SUBJECT: NATIONAL INSTITUTE OF STANDARDS AND TECHNOLOGY - ISSUANCE OF
AMENDMENT NO. 11 TO RENEWED FACILITY OPERATING LICENSE
NO. TR-5 FOR THE NATIONAL BUREAU OF STANDARDS TEST REACTOR
(CAC NO. 000955)

AMENDMENT TO RENEWED FACILITY OPERATING LICENSE

Amendment No. 11
License No. TR-5

SAFETY EVALUATION BY THE OFFICE OF NUCLEAR REACTOR REGULATION

Figure 6.1

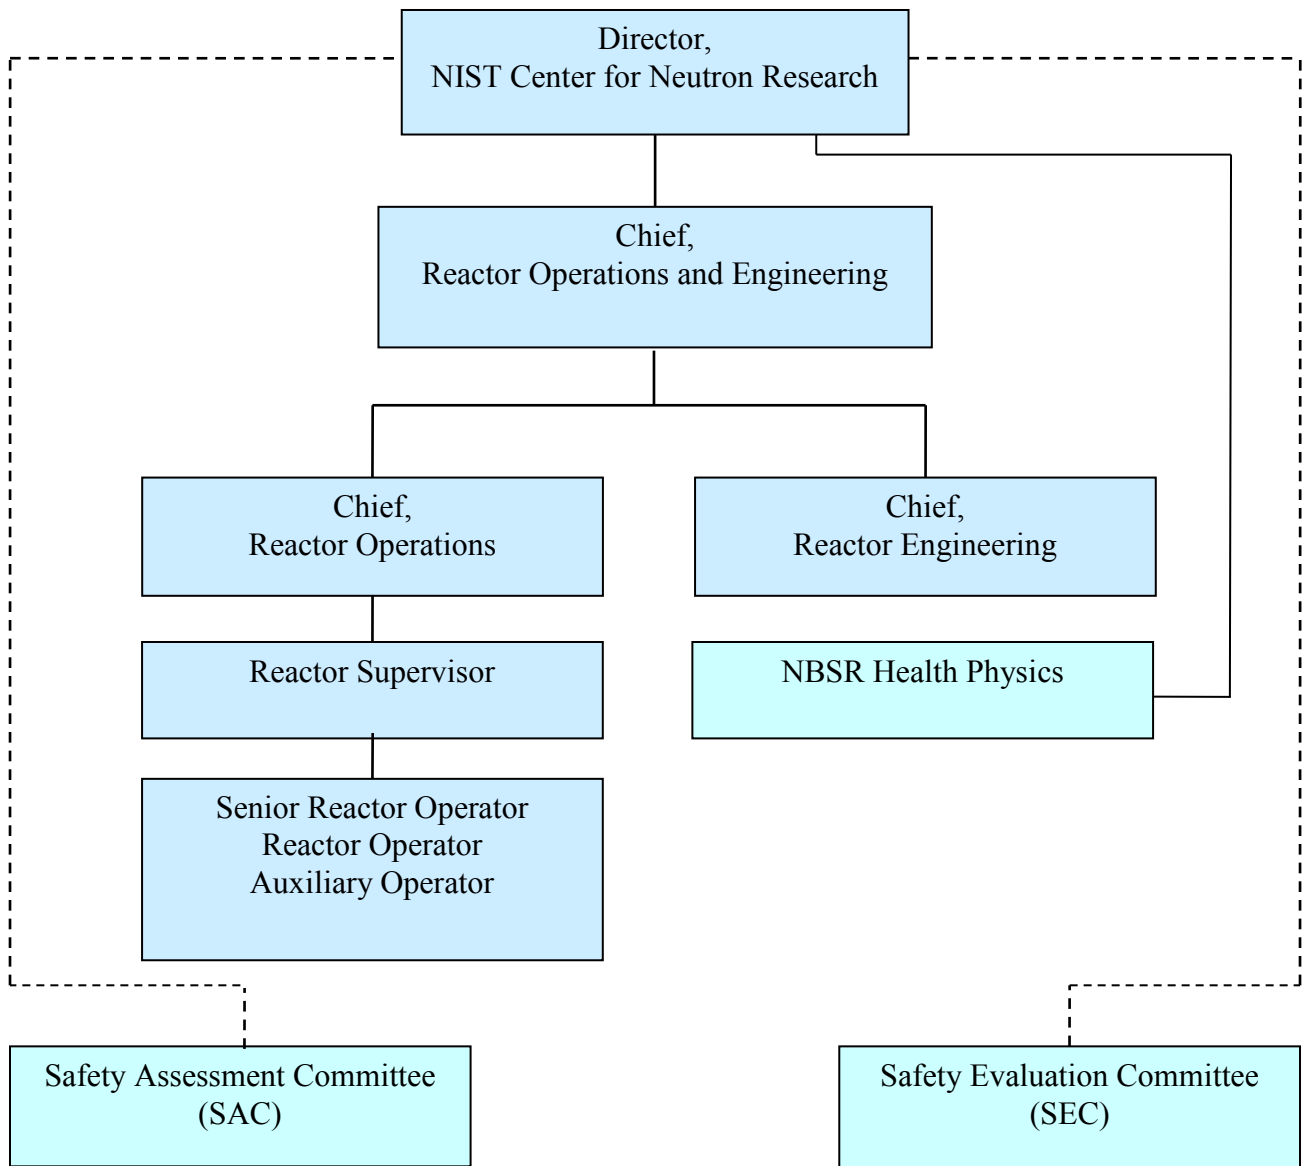
TS Figure 6.1 is the licensee's organization chart. The proposed change to TS Figure 6.1 would correct a line of reporting between the NBSR Health Physics and the Director, NIST Center for Neutron Research. The current TS Figure 6.1 does not show an "Administrative Reporting Channel," but shows reporting of "Recommendations and Technical Advice." The proposed figure changes this channel to "Administrative Reporting Channels," a direct reporting channel. Thus, the dashed line between the NBSR Health Physics box and the Director, NIST Center for Neutron Research box would be changed to a solid line to reflect this reporting change. This change will reflect the reporting channel that has been the actual reporting practice between the NBSR health physics and the reactor director.

2.3.8 TS "Figure 6.1"

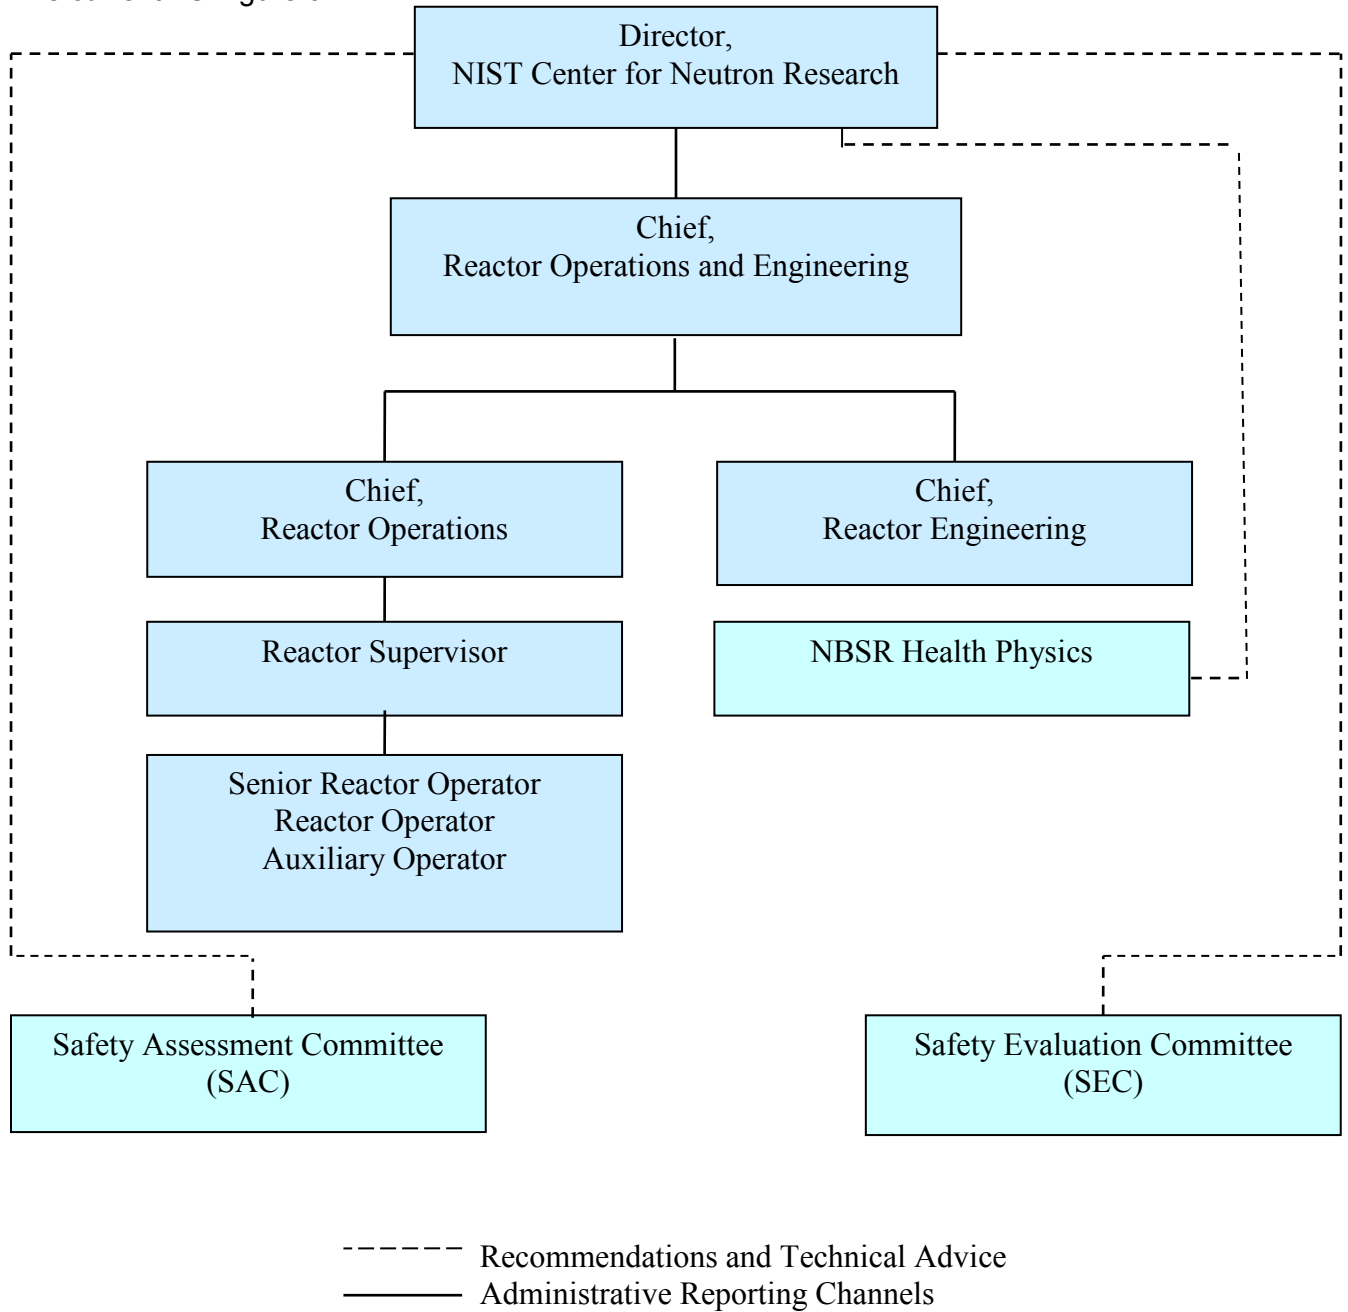
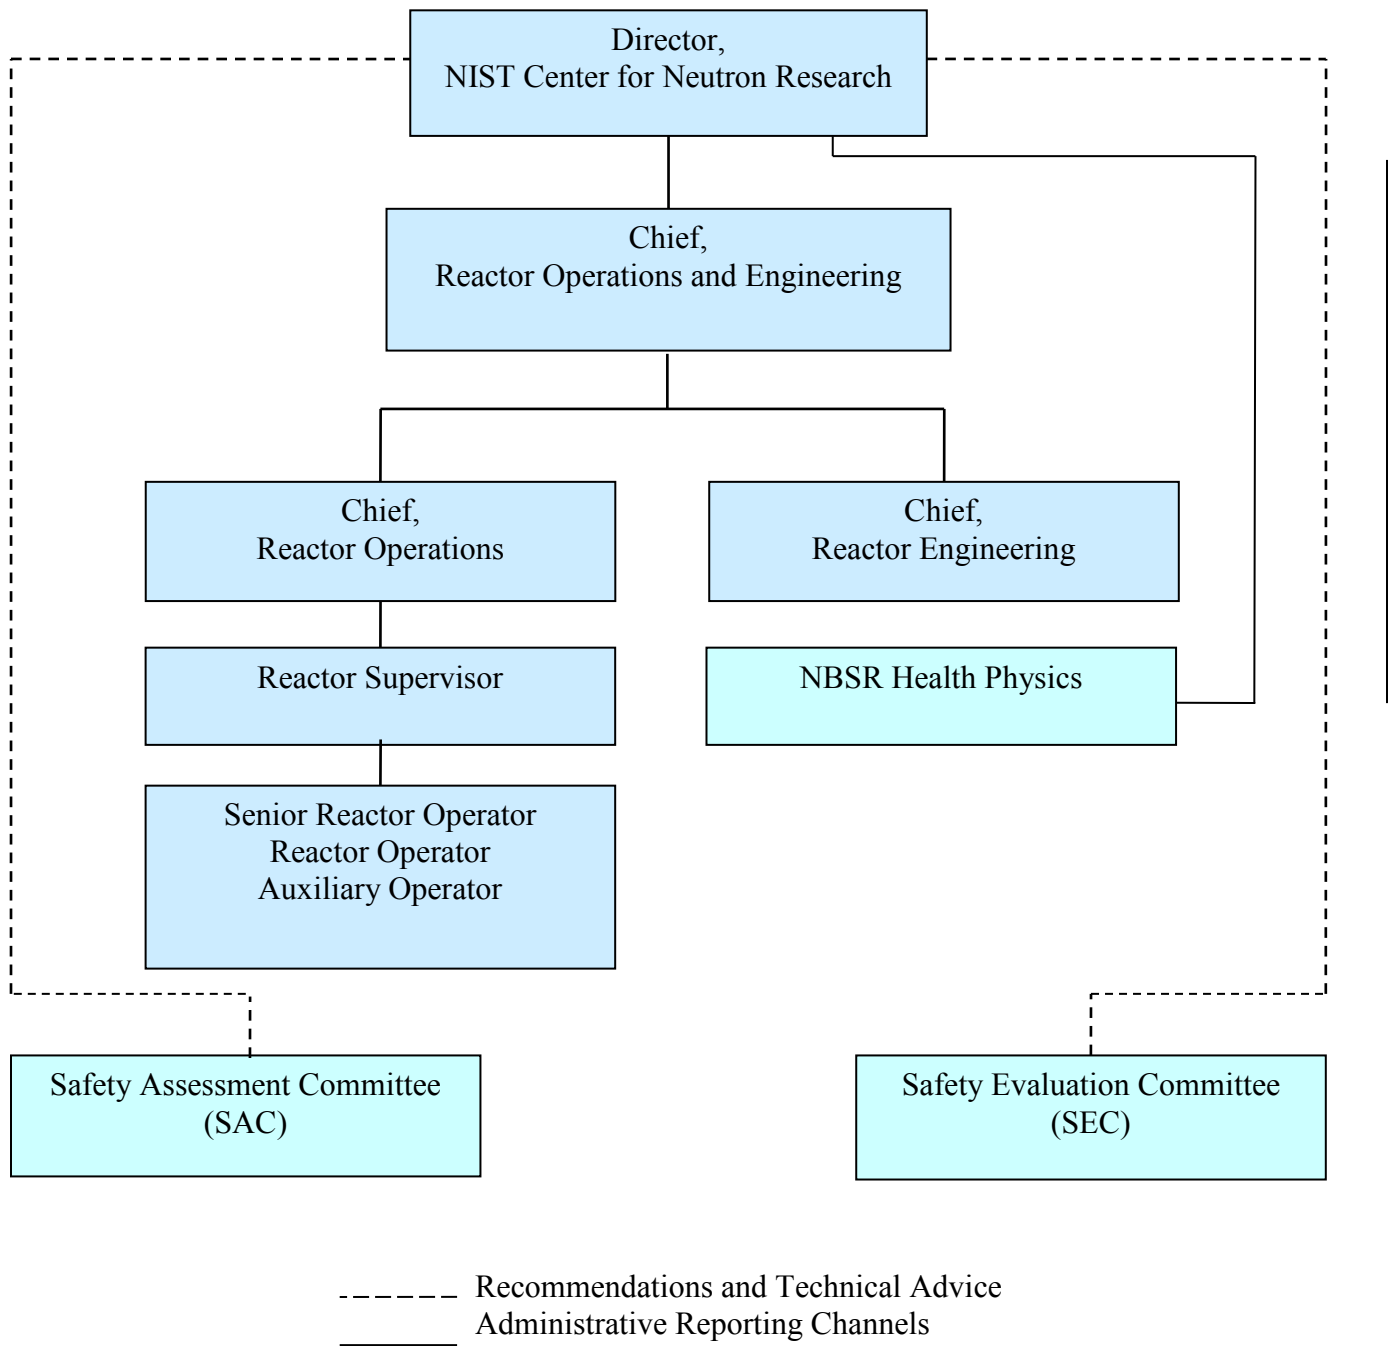
The current TS Figure 6.1:

The proposed TS Figure 6.1:

Based on its review, the NRC staff concludes that the change requires a direct administrative reporting function for the licensee's health physics in the organization and is consistent with the licensee's actual practice. NBSR health physics directly reports any radiation safety issues and concerns to the director. The NRC staff concludes that the change is corrective in nature, is consistent with the ANSI/ANS-15.1 standard that radiation safety personnel report to higher management in the organization, and is acceptable.
